Re: Unlicensed Operation in the TV Broadcast Bands, ET Docket No. 04-186 and Additional Spectrum for Unlicensed Devices Below 900 MHz and in the 3 GHz Band, ET Docket No. 02-380

On behalf of the National Cable & Telecommunications Association (“NCTA”), I submit the following proposed changes to the Commission’s rules concerning protection of cable headend facilities from interference from TV band devices (“TVBDs”). This proposed rule change is in follow-up to NCTA’s Petition for Reconsideration and Clarification (“Petition”) filed on March 19, 2009.

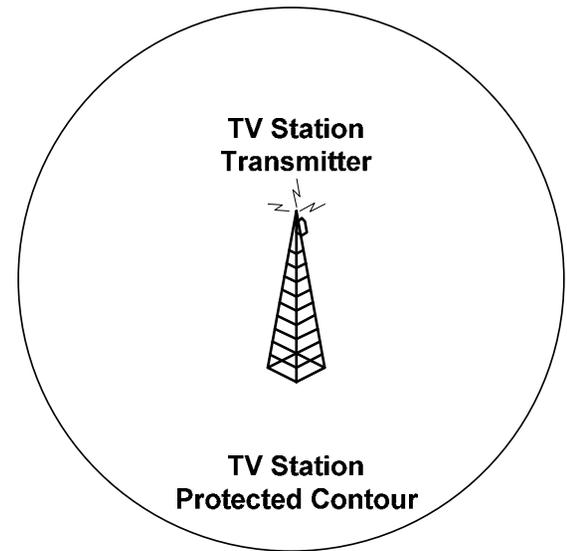
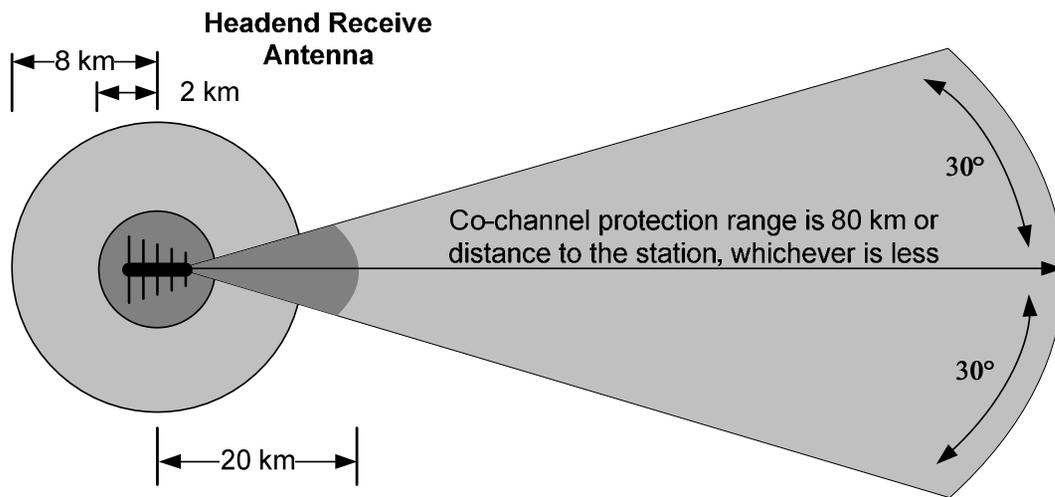
As discussed in NCTA’s Petition and during our August 6th meeting with OET, the rules and the text of the Order should be modified to make clear that the protection boundary for both co-channel and adjacent channel interference protection should be measured from the cable headend’s location rather than from the edge of the TV station’s contour. This modification also will clarify that protection is accorded to headends that may be located more than 80 km outside protected contour boundaries. We ask the Commission to correct the language in paragraphs 186 and 187 of the Order and amend section 15.712(b) of its rules as follows:

15.712(b) Translator receive sites and cable headends: For translator and cable headend receive sites registered in the TV bands database, TVBDs may not operate co-channel within an arc whose center is the receive site, whose radius is 80 km or the distance from the receive site to the TV station transmitter, whichever is less, and which extends +/-30 degrees from a line between the receive site and the TV station transmitter. TVBDs may not operate on adjacent channels within this same arc within 20 km of the receive site, unless the TVBD is a Mode II personal/portable device operating within the station’s protected contour, in which case Sections 15.712(a)(2) and 15.709(a)(2) shall apply. In addition to the above provisions, TVBDs may not operate within 8 km from the receive site for co-channel operation or within 2 km from the receive site for adjacent channel operation in any direction.
